Calvert Cliffs Nuclear Power Plant, Units 1 and 2  
Renewed Facility Operating License Nos. DPR-53 and DPR-69  
NRC Docket Nos. 50-317 and 50-318

Subject: License Amendment Request Regarding Emergency Operations Facility (EOF)  
and Joint Information Center (JIC) Relocation and Consolidation

**Calvert Cliffs Nuclear Power Plant Emergency Plan Mark-up**

Figure 5-2, Emergency Operations / Joint Information Center Facility

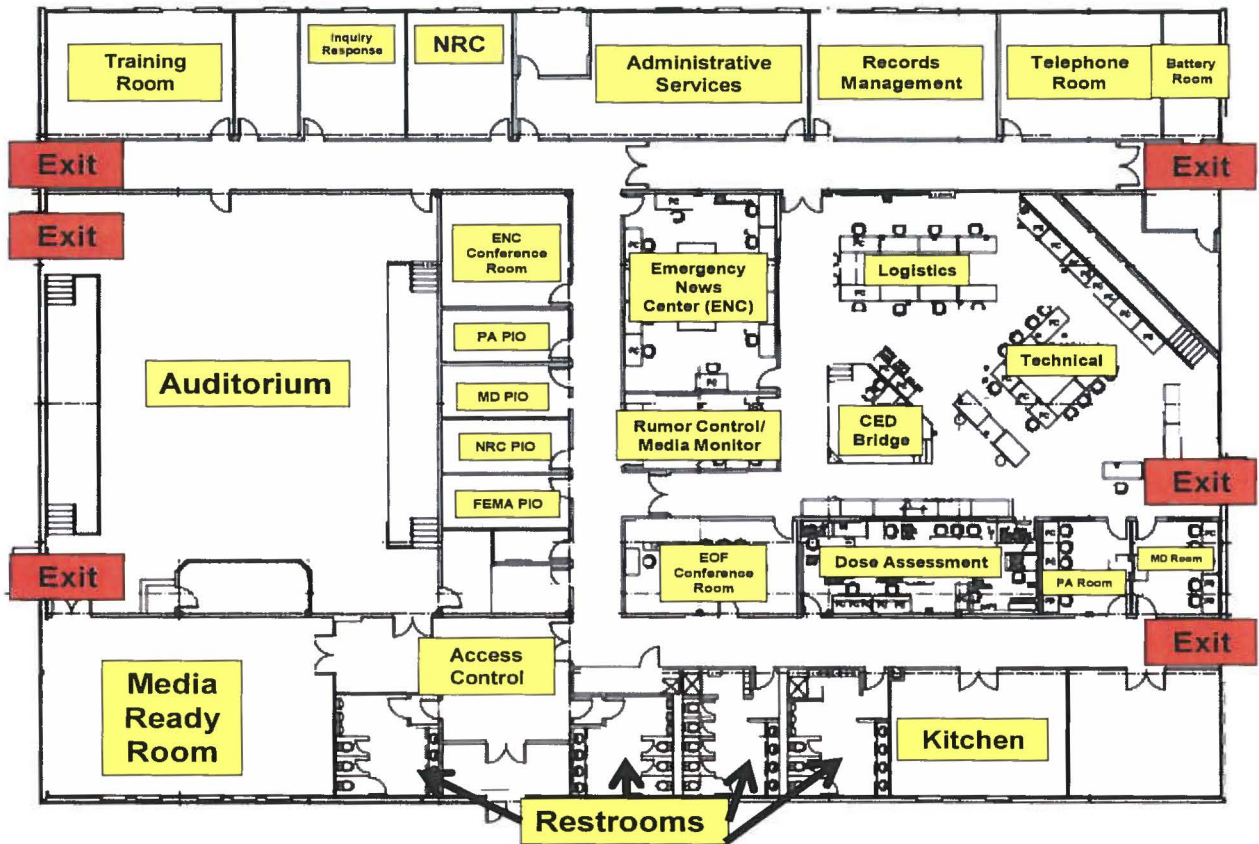
1. The Emergency Operations Facility floor plan is shown in Figure 5-2, Emergency Operations Facility, and its location at 175 North Caln Road, in Coatesville, Pennsylvania ~~Calvert County~~ is shown in Figure 5-3, Emergency Operations Facility and Joint Information Center Location.
2. The EOF is the location where the Corporate Emergency Director will direct a staff in evaluating and coordinating the overall company activities involved with an emergency.

1. The Joint Information Center location is shown in Figure 5-3, Emergency Operations Facility and Joint Information Center Location.

~~3.2.~~ The Joint Information Center is located about 115 ~~twelve~~ miles from the site, in ~~Calvert Industrial Park~~ Coatesville, Pennsylvania ~~Skipjack Road at Hallowing Point Road~~. It is a well-engineered structure for design life of the ~~Calvert Cliffs Nuclear Power Plants~~ it supports.
